The Best Alternative

Alternatives to Energize Eastside

Response to Draft EIS

Prepared for:
CENSE

(EIS Fig. 2-14) Theoretical example of Energy conserved or distributed generation

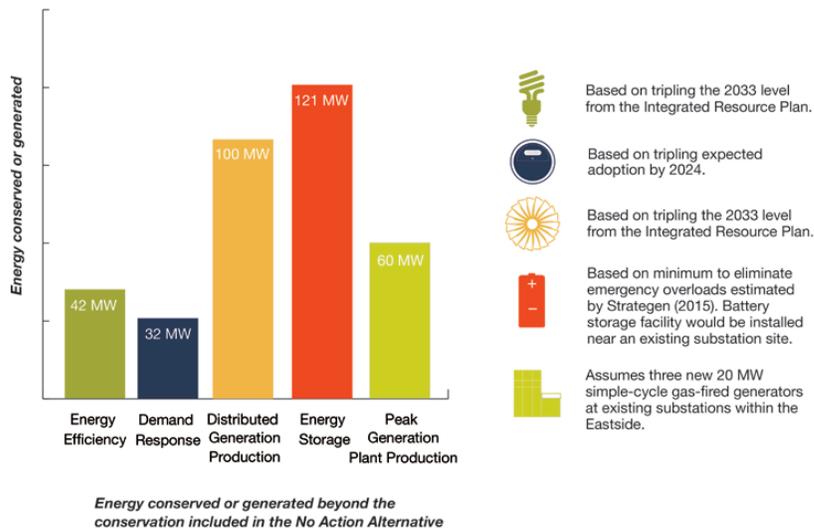
The EIS provides only a theoretical example of technology that could address winter peak load reductions which has no value in determining feasibility. See example graph in Fig. 2-14 in EIS.

In order to properly assess an Integrated Approach the EIS should either hire independent consulting firm to estimate cost effective DER on Eastside, or issue an all source RFP for all DER in affected eastside area. This process would include all avoided costs and provide actual estimates for DER capacity amounts and cost, as well as real vendors estimates. This process is being used in New York’s Brooklyn-Queens Demand Management program which started in 2014. New York utility ConEd is expected to invest \$200MM to implement DER to avoid transmission build.

Figure 3: PSE 2015 IRP *Figure 5-21: Electric Peak Demand Forecast before DSR 2015 IRP Base Scenario versus 2013 IRP Base Scenario Hourly Annual Peak (23 Degrees, MW)*

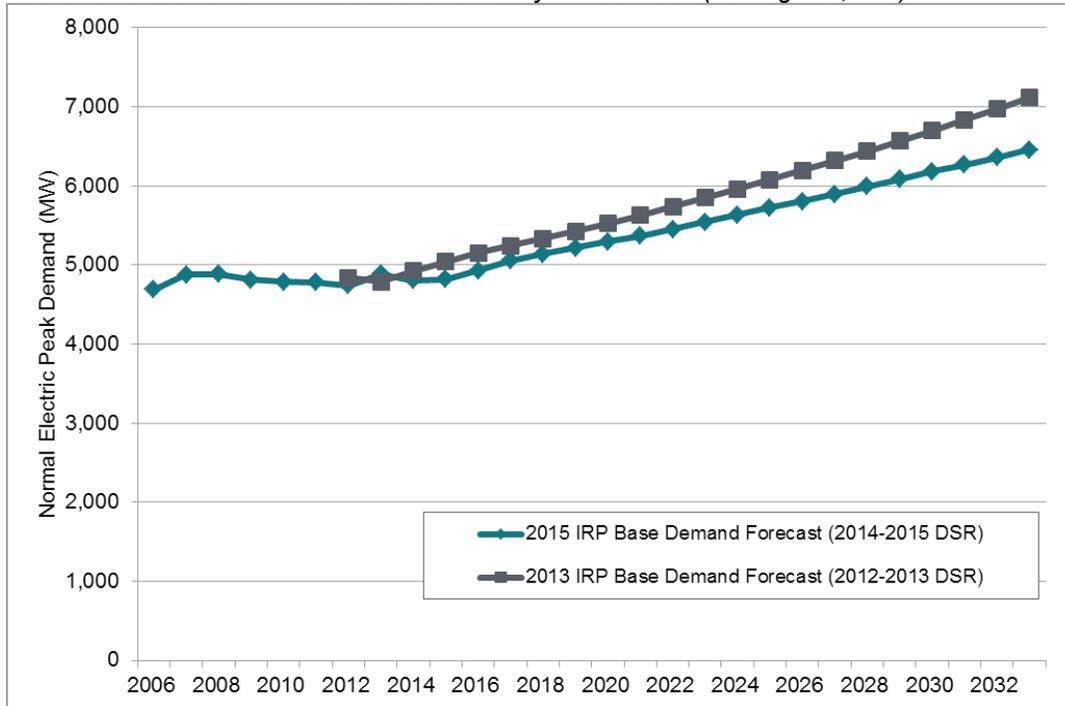
Figure 2 below shows how peak load is historically flat, then suddenly takes off in the future. You'll find this to be true with PSE's previous peak load forecasts. I understand that forecasts are, by their nature are wrong, but PSE has a habit of overestimating peak load.

Winter peaks have gone down in the Pacific Northwest in the last 5 years, and growth in the winter peak will continue to be less than the increase in growth in energy use. PSE's winter peak decreased by 11 MW from 2013 to 2014. This holds true because:

Figure 5-27: Electric Peak Forecasts by County (MW), after applying 2013 IRP DSR

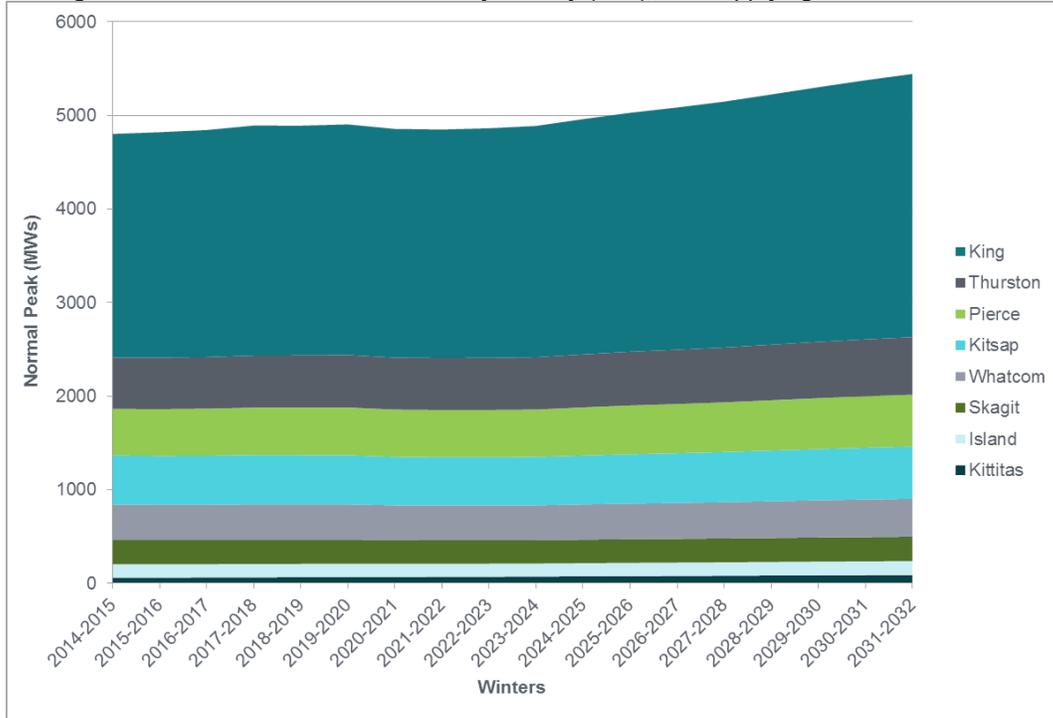
Notice in Figure 5-27 from PSE's 2015 IRP, the peak demand does not begin to increase until 2024.
